DEVELOPMENT REVIEW BOARD  
September 28, 1993  
S-93-30/DRB-93-104/SV-93-33

S-93-30 Ryals Engineering, agents for Jane Davidson, request a Sidewalk  
DRB-93-104 Variance and Preliminary Plat approval (includes grading approv-  
SV-93-33 al) for approximately 20 lots on Tracts 2 & 3, Kelly Tracts Sub-  
(NW) division, zoned RA-2 (City) and located on the west side of  
Gabaldon Rd NW between Mountain Rd NW and Interstate Route 40,  
containing approximately 6.94 acres. (H-12, J-12)

RE: DRAINAGE REPORT FOR CASAS A RIO (J-12/D15).  
RECEIVED JUNE 21, 1993 FOR PRELIMINARY PLAT APPROVAL  
ENGINEER'S STAMP DATED JUNE 21, 93

# CASAS A RIO SUBDIVISION

## TYPICAL LOT DRAINAGE PLAN

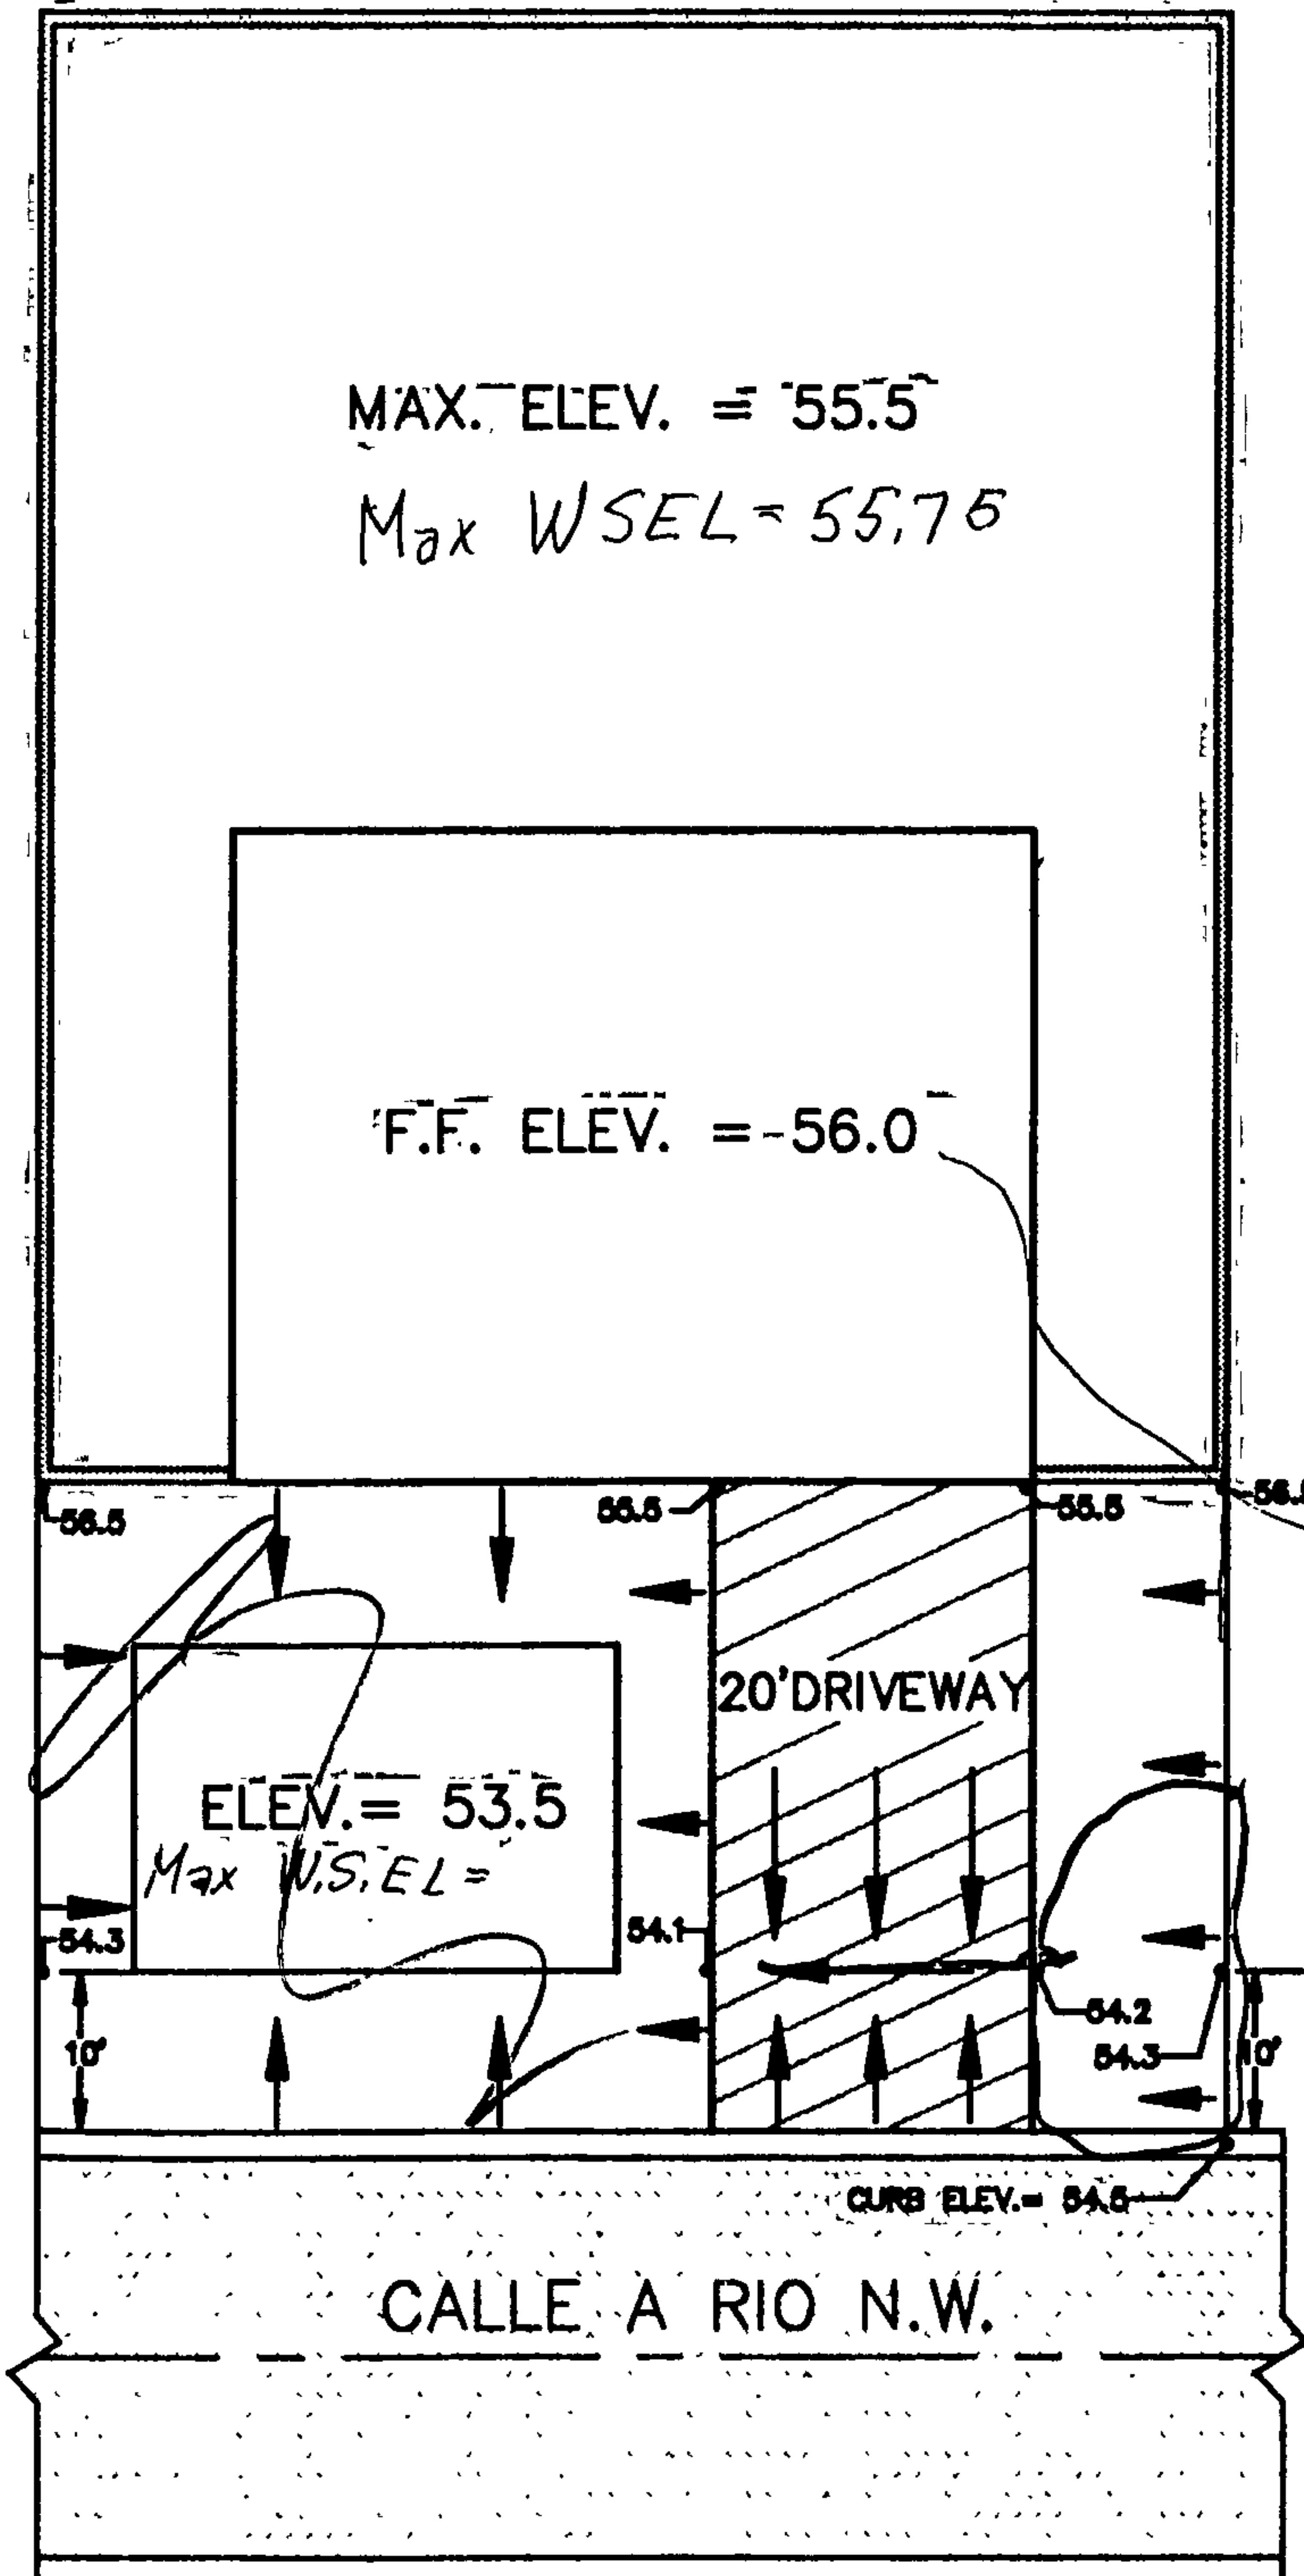
*Will this meet FEMA  
Flood proofing requirements  
1' above Max WSEL*
